SSINS No.: 6835
IN 86-70

August 18, 1986

IE INFORMATION NOTICE NO. 86-70: POTENTIAL FAILURE OF ALL EMERGENCY
DIESEL GENERATORS

FIGURE 1
TURKEY POINT - UNITS 3 & 4 *

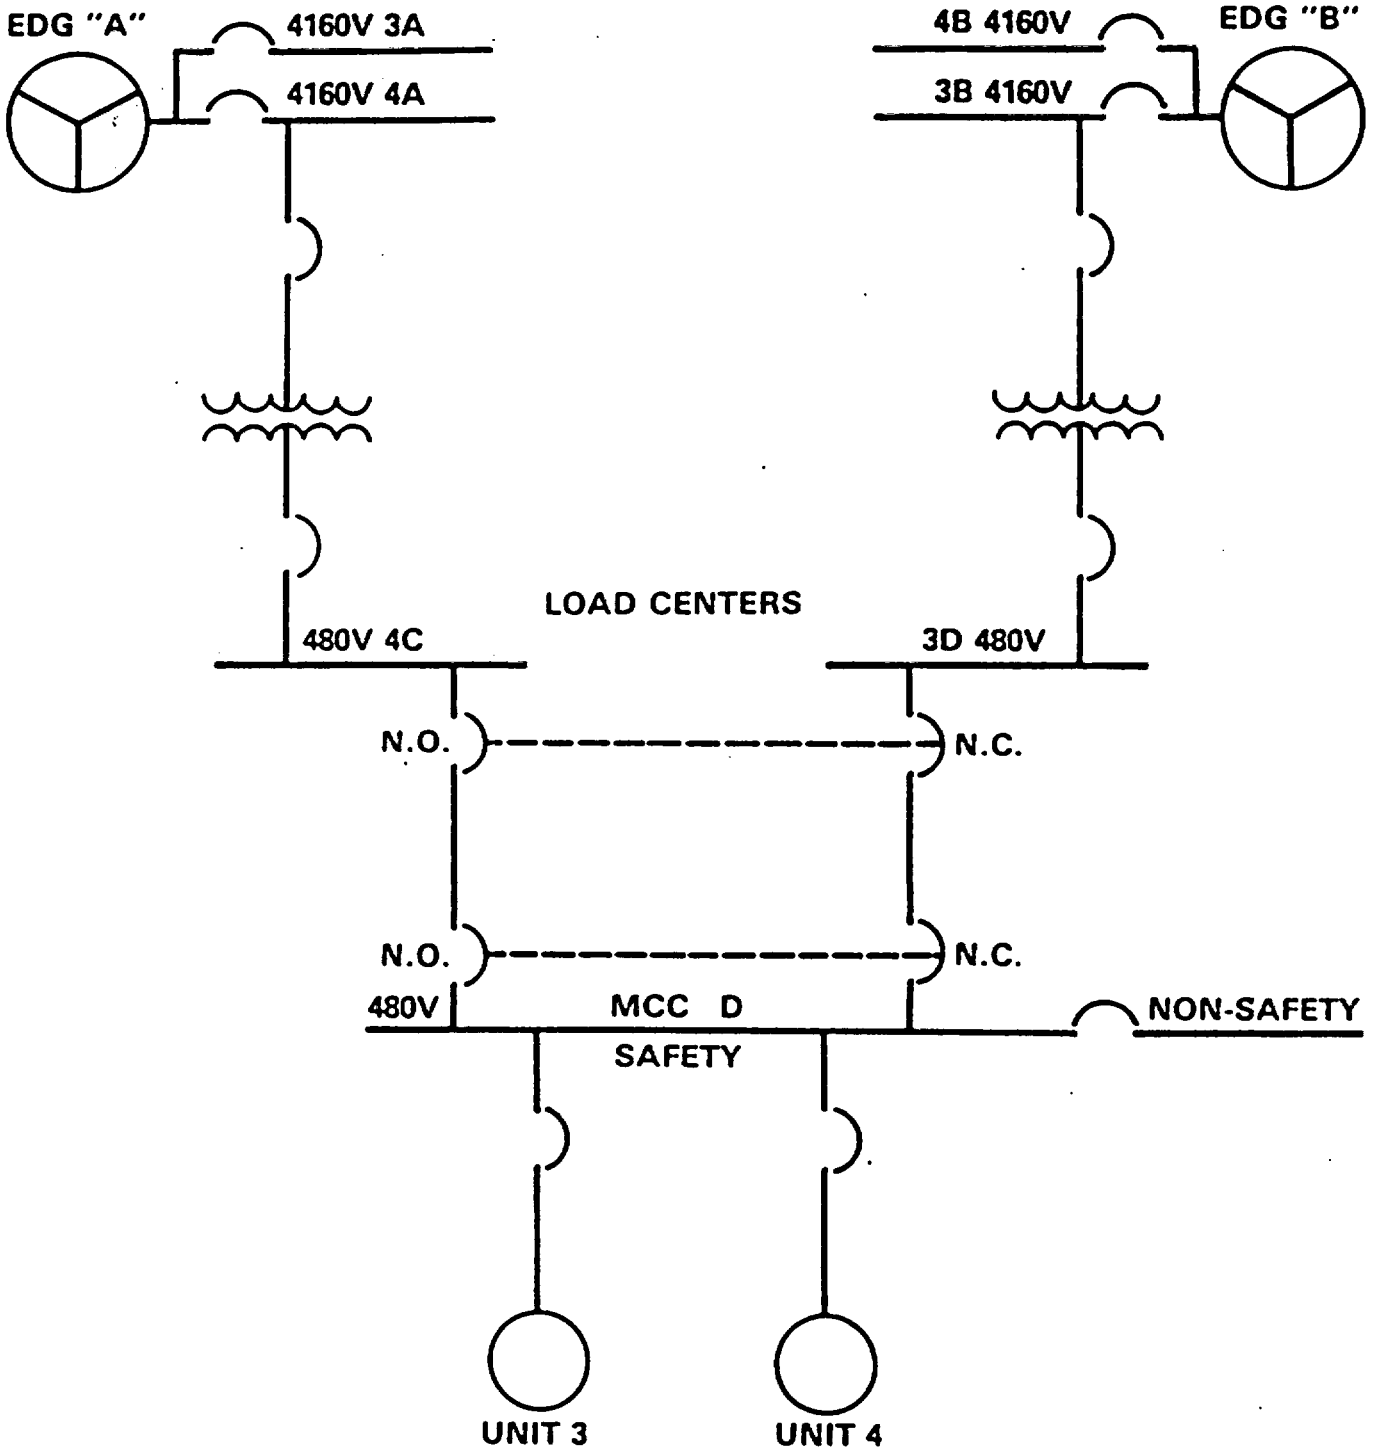
One design deficiency involved a "swing bus." As shown on Figure 1, 480 volt MCC "D" is normally supplied from EDG "B" but will shift its power supply to EDG "A" if needed. MCC "D" also feeds a non-safety stub bus through a single circuit breaker. This breaker is normally opened by the 4B load sequencer to isolate the non-safety loads from MCC "D" when the 4B 4160V bus is loaded on EDG "B". A single failure in that circuit breaker would leave the non-safety loads connected to MCC "D". During safety injection for one unit, the additional non-safety loads could overload EDG "B", possibly resulting in a trip of this EDG. MCC "D" would then transfer its power supply and could overload EDG "A" as well.

As an interim solution to the above design deficiencies, FP&L disabled the automatic transfer between EDGs and established a dedicated operator to take corrective action (i.e., manipulate appropriate breakers) as necessary. The licensee has now modified EDG loads, loading sequences and plant procedures. This example illustrates the importance of reviewing EDG load limits under all possible operating configurations for a range of design basis accident conditions. FP&L, through an FMEA, system testing, and evaluation of EDG load limits, found design deficiencies that may have prevented one or both EDG's from performing their required function.

FIGURE 2
TURKEY POINT - UNITS 3 & 4*

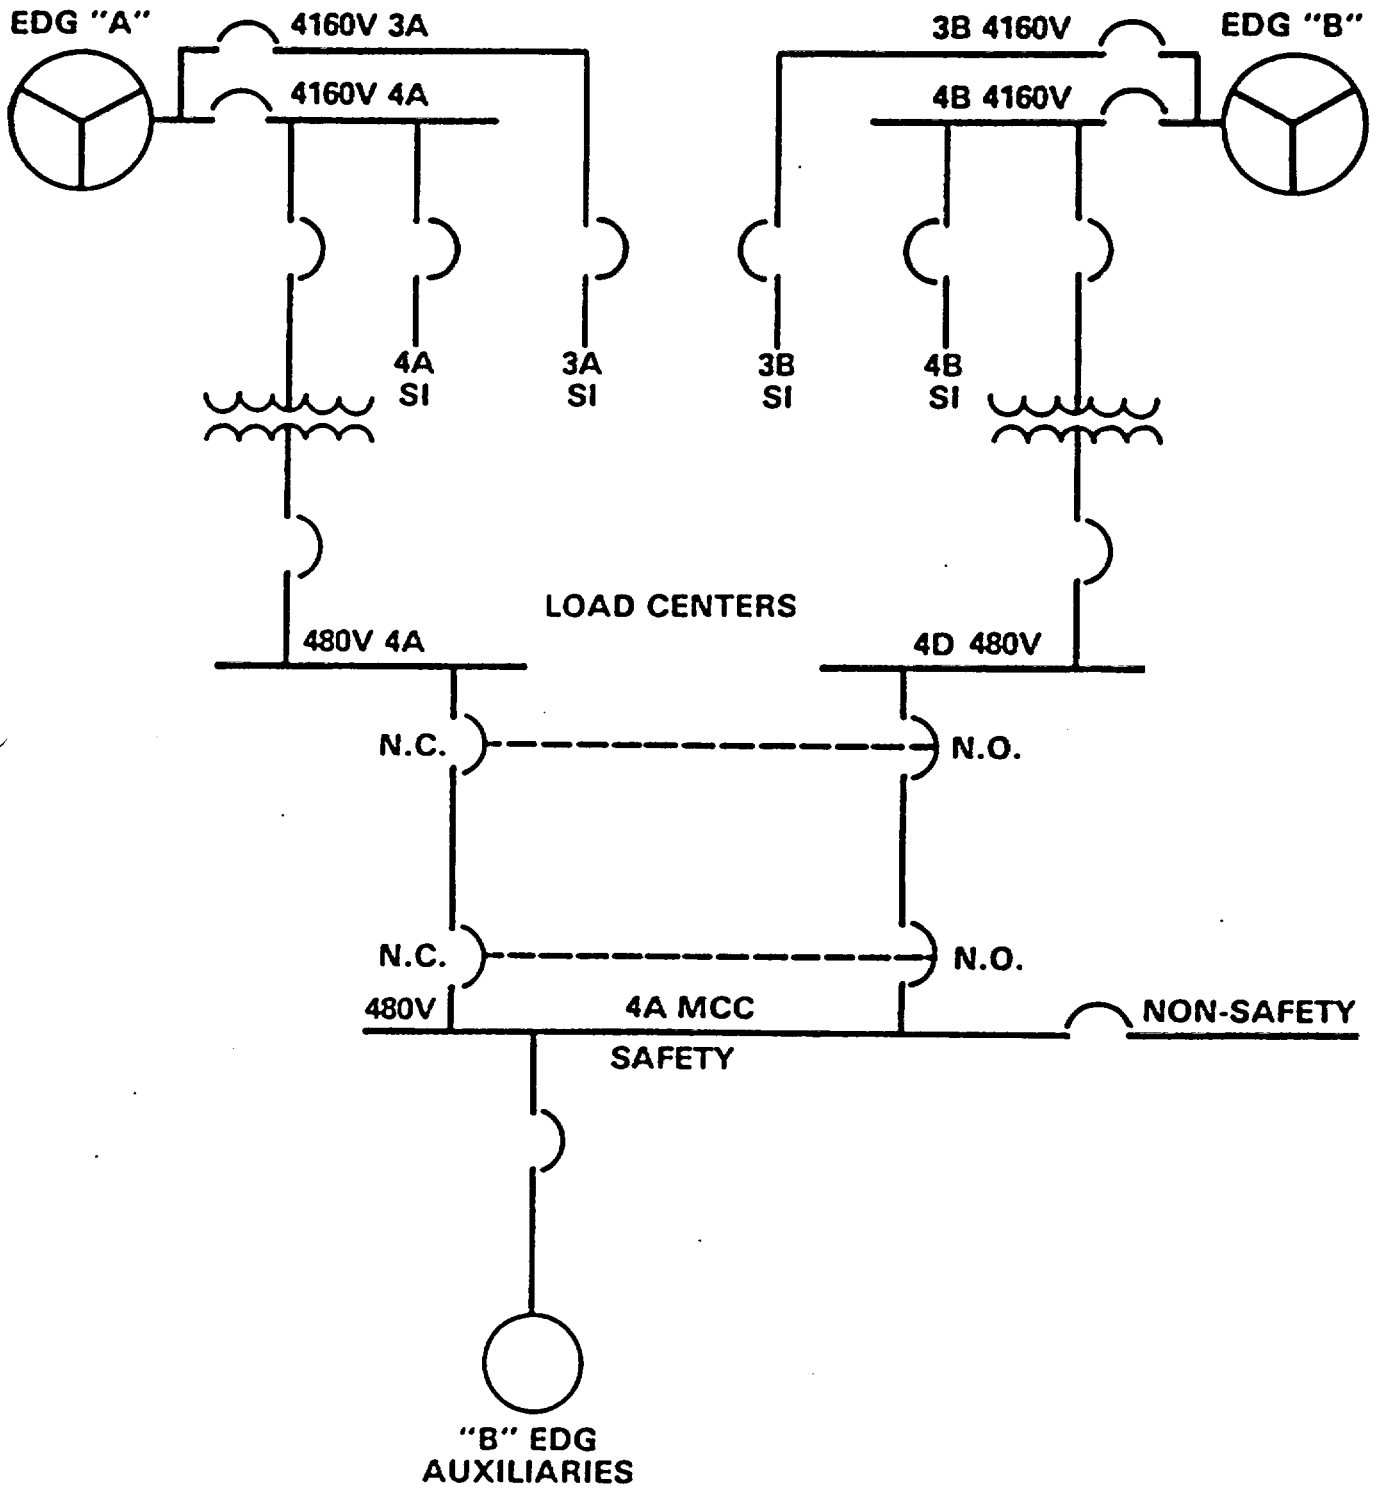
In addition to the overloading deficiencies above, a design deficiency was found that could result in the loss of one EDG, and at the same time could result in the loss of all ac power to Unit 4 as mentioned earlier. In the event of a single failure of the 4A battery or the 4A load sequencer subsequent to a loss of off-site power, the 4A 4160V bus shown in Figure 2 would be prevented from automatically loading onto the "A" EDG. It would also prevent the transfer of the 4A MCC swing bus from 4A load center to 4B load center. The "B" EDG has a self-contained supply of fuel oil that lasts about one hour. After that time, fuel must be gravity supplied by the day tank via a solenoid operated valve. However, this valve is powered from MCC 4A. Therefore, the above mentioned single failure would also cause the loss of the "B" EDG and the loss of all ac power to Unit 4. The Unit 3 3B 4160V bus would also be deenergized, along with three of the four high head safety injection pumps and the control room air-conditioning.
